Subject: FW: Urgent! - Suncorp Communications Limited, FCC ID: S9AWDCT45-AS, Assessment NO.: AN05T5197, Notice#1

Question #1: SAR Test Plots - Please provide a "color" copy (SAR Report Part 5). It is very difficult to find hot spot, as well as other detailed information, based upon black-white images.

Date: 13.OCT.2005 20:14:59

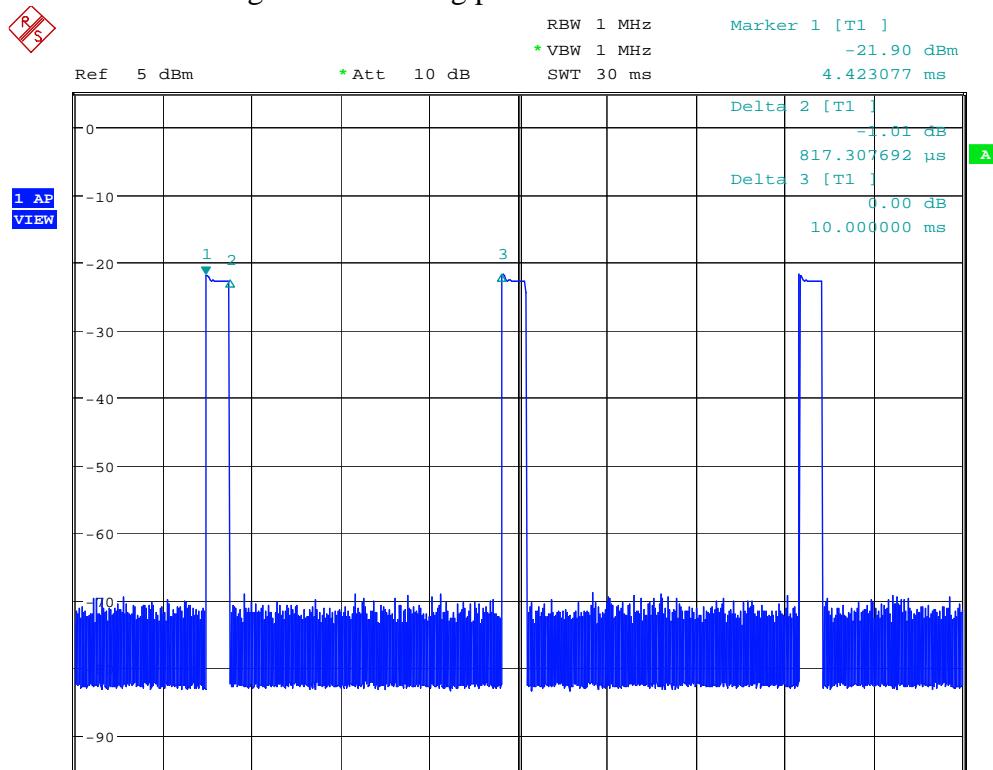
Question #2: SAR Test plots - Please justify why duty cycle = 1:12 was selected during the SAR test.

Question #2: SAR Test plots - Please justify why duty cycle = 1:12 was selected during the SAR test.

To use a spectrum (R&S FUS46) to scan with time domain the air-interface nearby of the handset under test and get the following picture:

The duty period was between point 1 and 2 marked and the value was about 0.8 ms.

The cycle-period was between point 1 and 3 marked and the value was 10ms.

So, the duty cycle can be calculated by 0.8/10, the value is 0.08 and it is very close to 1: 12.
